**APPLICATION FOR A CERTIFICATE OF APPROPRIATENESS FOR
A SIGN IN A SPECIAL PROVISION SIGN DISTRICT (SPSD)**

CASE NUMBER: SIGN-25-002009

LOCATION: 1909 BRYAN ST

REQUEST: An application for a Certificate of Appropriateness by Francisco Silva of Silva Signs & Service, for a 76.6-square-foot LED illuminated flat attached sign at 1909 BRYAN ST (EAST ELEVATION).

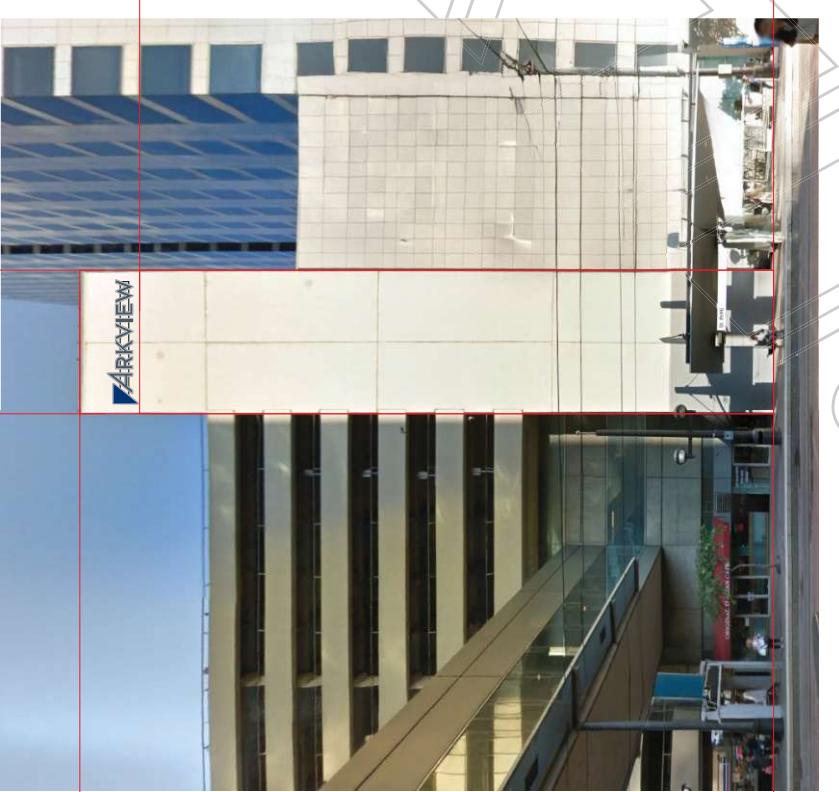
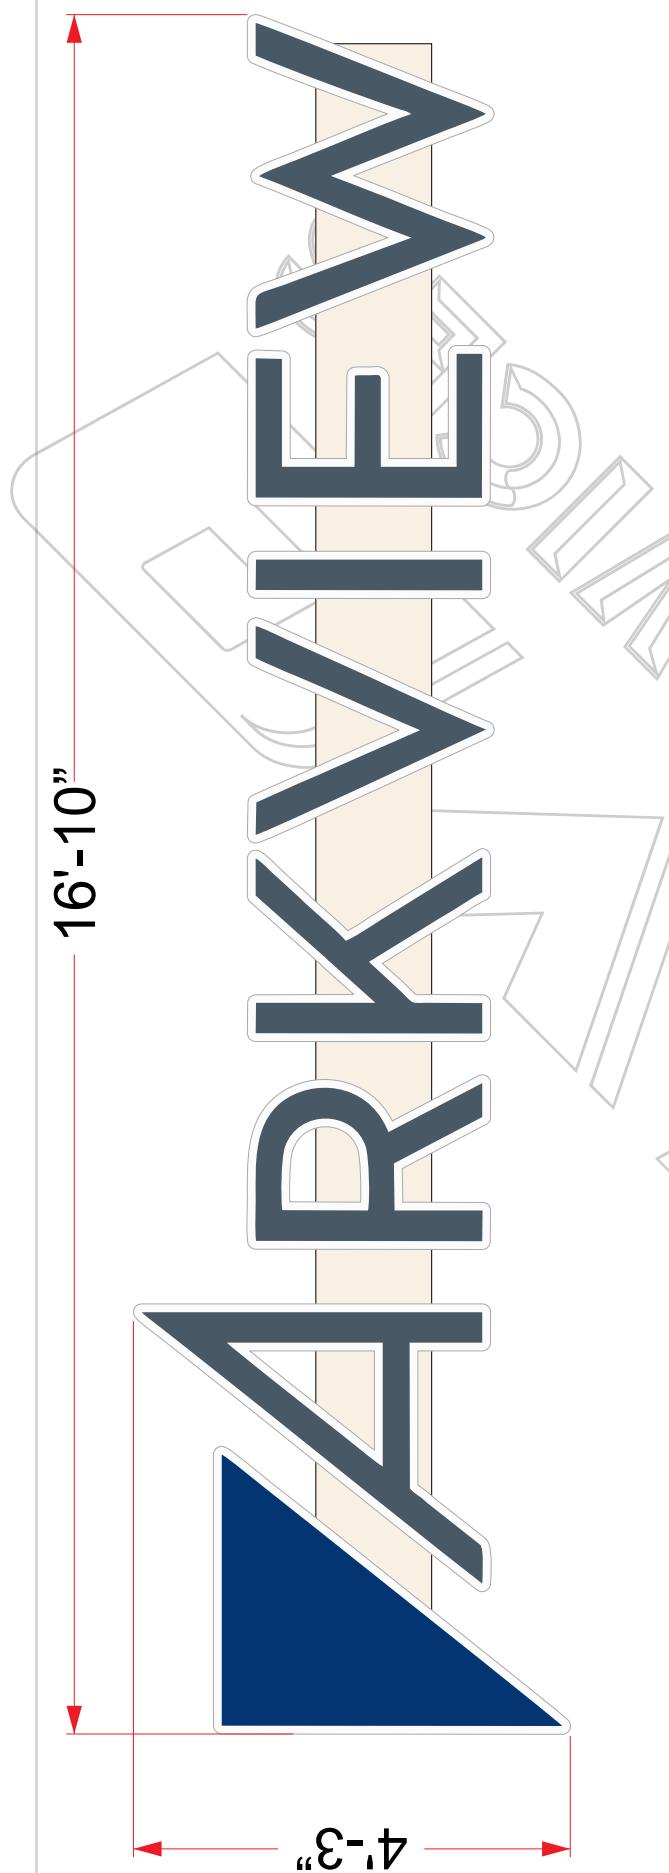
This is the only sign proposed on this façade. The sign is allowed up to 30% of the façade but only occupies approximately 2% of it.

This sign will contain two words, and is wholly located within the upper level sign area.

STAFF RECOMMENDATION: Approval

SSDAC RECOMMENDATION: Approval
